SUBJECT: COMANCHE PEAK STEAM ELECTRIC STATION (CPSES)
DOCKETS NOS. 50-445 AND 50-446
REQUEST FOR ADDITIONAL INFORMATION - NUREG-0737, ITEM II.D.1
PERFORMANCE TESTING OF RELIEF AND SAFETY VALVES

By letter dated March 27, 1987, the NRC staff requested additional information regarding the TU Electric submittal of June 13, 1986, "NUREG-0737, Item II.D.1 - Performance Testing of Relief and Safety Valves".

WESTINGHOUSE ELECTRIC CORPORATION		(V)
PITTSBURGH, PA.		
AUTHOR: <i>W. J. Dierker</i>		
CUSCHER: <i>W. J. Dierker</i>		9 10 87
OPEN HEAVY PIPING MODEL		
STRESS PROBLEM 1-083		
FIGURE A-2		
PAGE 3-48 BEFORE	USE CRT. 88	
PAGE 3-87 AFTER	USE CRT. 36	
SCALE: N.T.S.	DRAWING NO.	REV
JOB NO.	SHEET 8 OF 8	Q

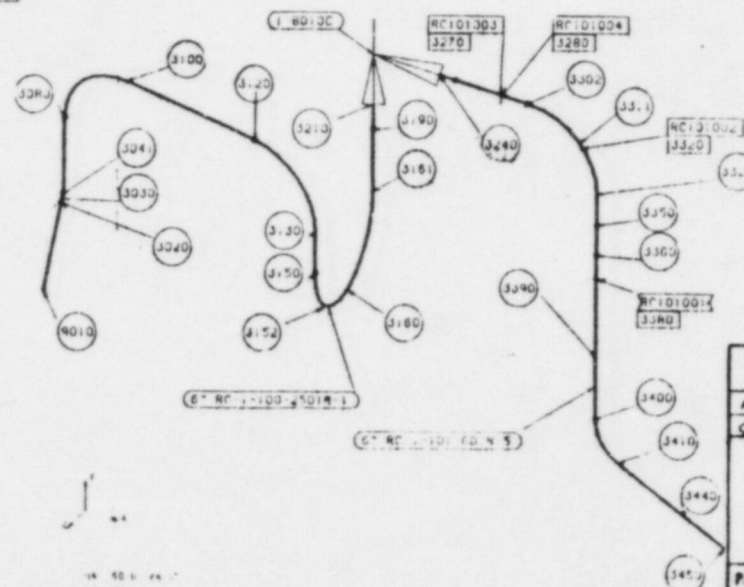
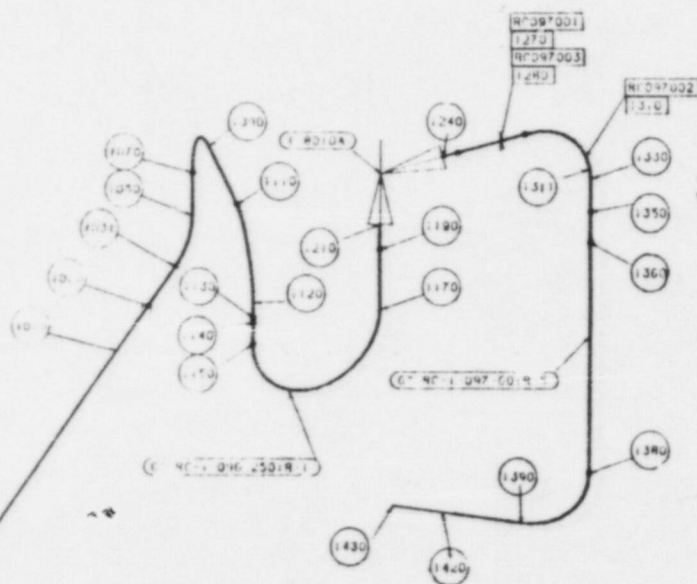
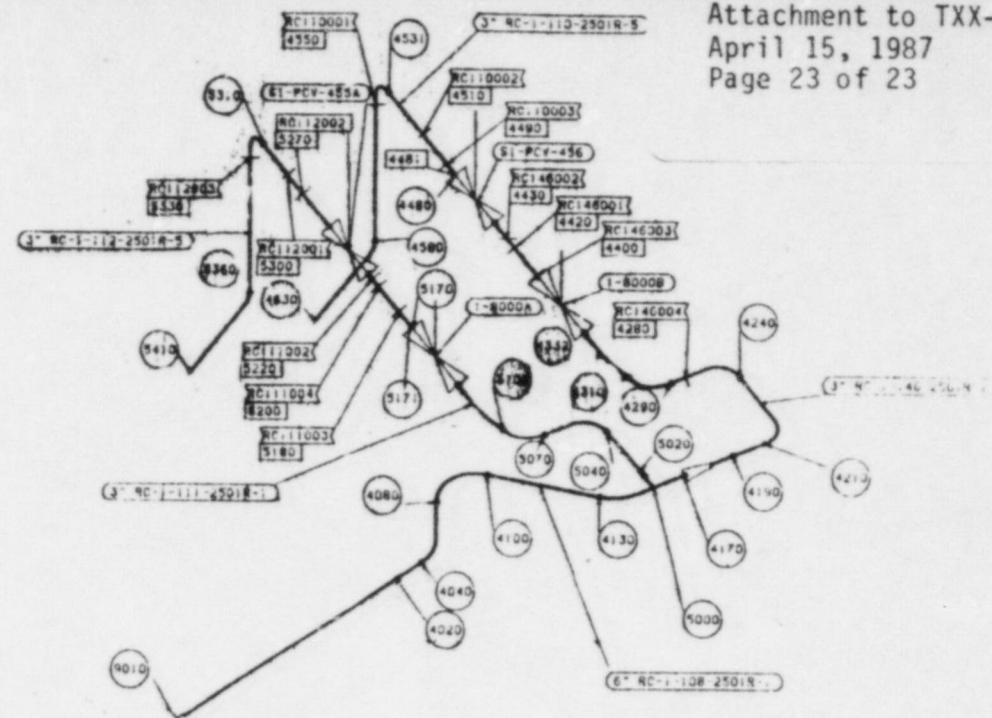
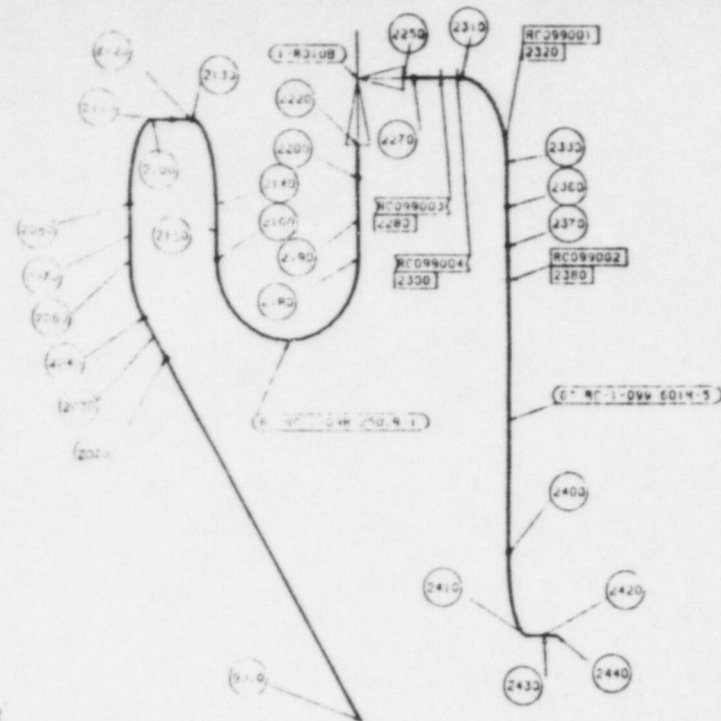
- C. Provide sketches of the upstream and downstream piping indicating the locations of the structural nodes used in the stress comparisons.

RESPONSE 2: Since the transmittal and review of the reference data, the line
(cont'd) has been reanalyzed to reflect pipe support changes. A comparison of the normal, upset, emergency and faulted condition stresses and the applicable stress limits for both the upstream and downstream piping is presented in the attached Tables 2-1 through 2-9 for the revised analysis. Figures A-1 and A-2 illustrate the structural node points and support locations.
